Access Compliance Report

Public Rights-of-Way

(Pedestrian Signals)

Intersection ID: N/A	Main Street:	Cross Street: N/A	Location: N/A
ADA ID: 3E2B18EC8F76	Signal Type: Two Push Buttons-Non APS	Overall Compliance: No	Severity Score: BTN 1:N/A BTN 2: N/A No BTN: N/A
Codes/Mitigation Info/Possible Solution		Field Measurements/Component Compliance

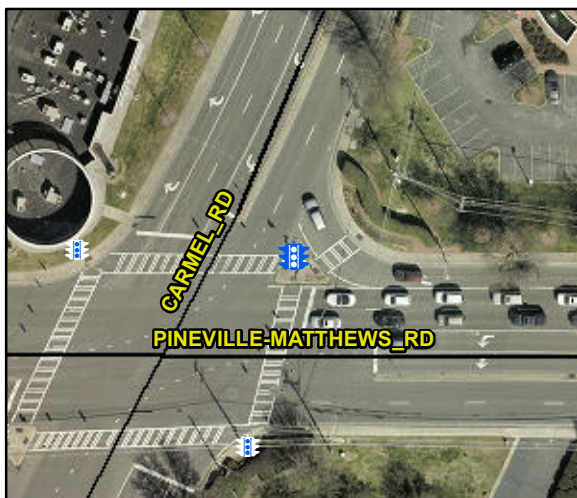
PROW/ADA: TMUTCD 4e.08, R404.2, R406.2

N/A	B 1 FWD Approach Width (in)	N/A	N/A	B 2 FWD Approach Width (in)	N/A
N/A	B 1 FWD Approach Obstruction?	Yes	N/A	B 2 FWD Approach Obstruction?	N/A
N/A	B 1 FWD Approach Obstruction Dist (in)	6.0	N/A	B 2 FWD Approach ObstructionDist (in)	N/A
N/A	B 1 PARA Approach?	Yes	N/A	B 2 PARA Approach?	Yes
N/A	B 1 PARA Approach Constrained?	No	N/A	B 2 PARA Approach Constrained?	No
Yes	B 1 PARA Approach Reach (in)	6.0	Yes	B 2 PARA Approach Reach (in)	6.0
N/A	B 1 PARA Approach Width (in)	N/A	N/A	B 2 PARA Approach Width (in)	N/A
N/A	B 1 PARA Approach Obstruction?	Yes	N/A	B 2 PARA Approach Obstruction?	Yes
N/A	B 1 PARA Approach Obstruction Dist (in)	6.0	N/A	B 2 PARA Approach ObstructionDist (in)	6.0
Yes	B 1 Clear Floor Space Slope (%)	1.6	Yes	B 2 Clear Floor Space Slope (%)	4.9
No	B 1 Clear Floor Space XSlope (%)	4.9	Yes	B 2 Clear Floor Space XSlope (%)	1.6
N/A	B 1 PAR Slope (%)	1.6	N/A	B 2 PAR Slope (%)	4.9
Yes	B 1 Height (in)	39.0	Yes	B 2 Height (in)	39.0

Yes	B 1 Clear Xing Direction?	ClearlyMarked	Yes	B 2 Clear Xing Direction?	ClearlyMarked
	B 1 Crossing Direction	To W		B 2 Crossing Direction	To S
Yes	B 1 DistanceTo XWalk (in)	0.0	Yes	B 2 DistanceTo XWalk (in)	0.0
No	B 1 DistanceTo Curb (in)	80.0	No	B 2 DistanceTo Curb (in)	156.0
Yes	B 1 Diameter (in)	2.0	Yes	B 2 Diameter (in)	2.0

Possible Solutions: Replace Signal Push Button With APS Button on New Post. Remove & Relocate Sign.
